CONSOLIDATED EDISON COMPANY  
OF NEW YORK, INC.

Indian Point Unit No. 2

Further Responses to Questions Asked  
by the Citizens Committee for the  
Protection of the Environment

February 12, 1971

Figure 1

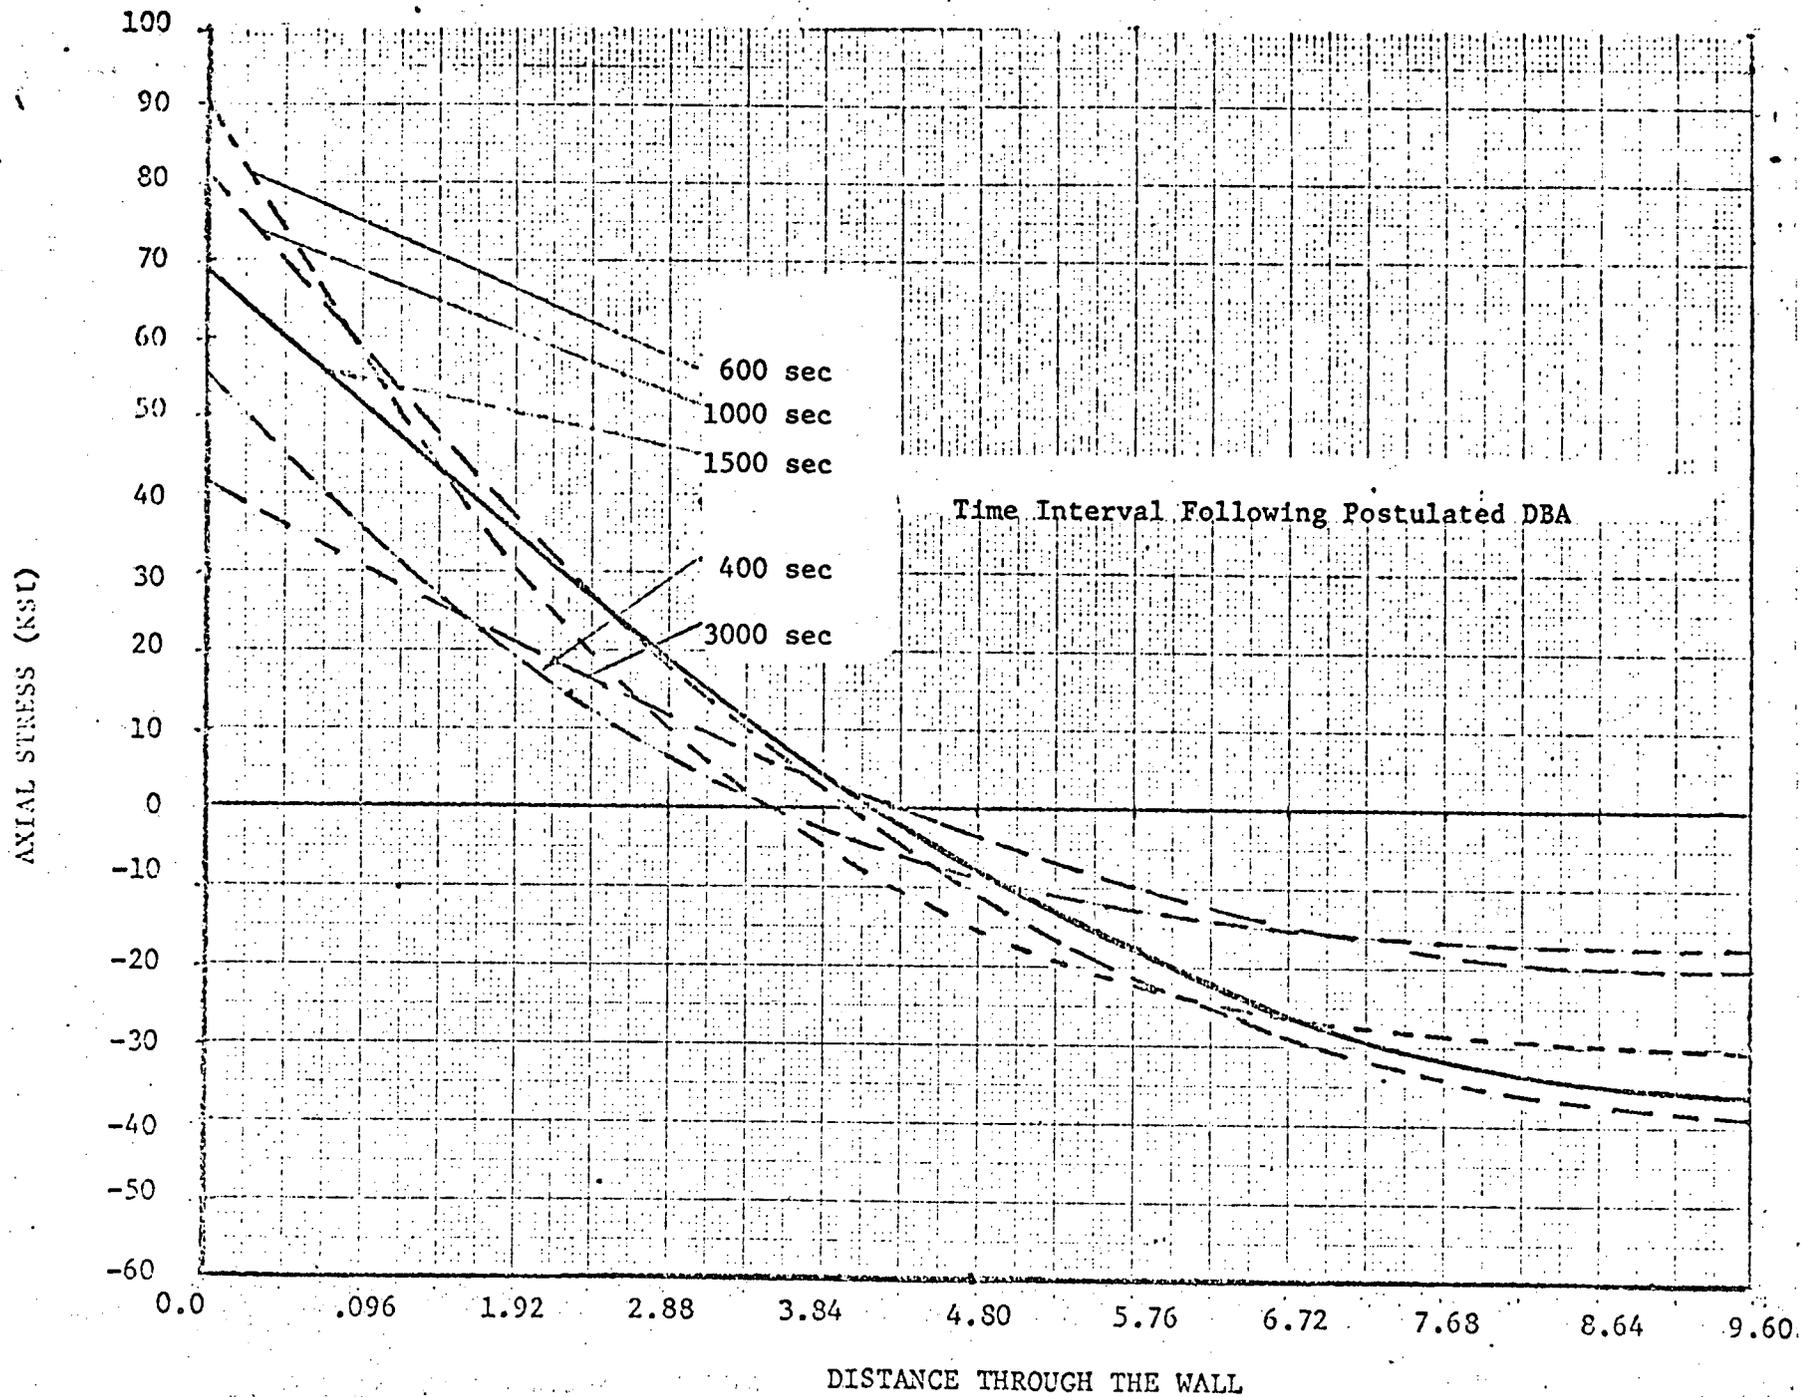
Question No. D-50

Answer: THERMAL STRESSES

The stresses in the reactor vessel due to a radial temperature gradient are somewhere between the plane stress lower bound (thin disc) and the plane strain upper bound (long cylinder). In this calculation plane strain is assumed for conservatism.

The temperatures were calculated using equation 2, and the stress profiles were then calculated by equation 1. The results are shown in figure 1.
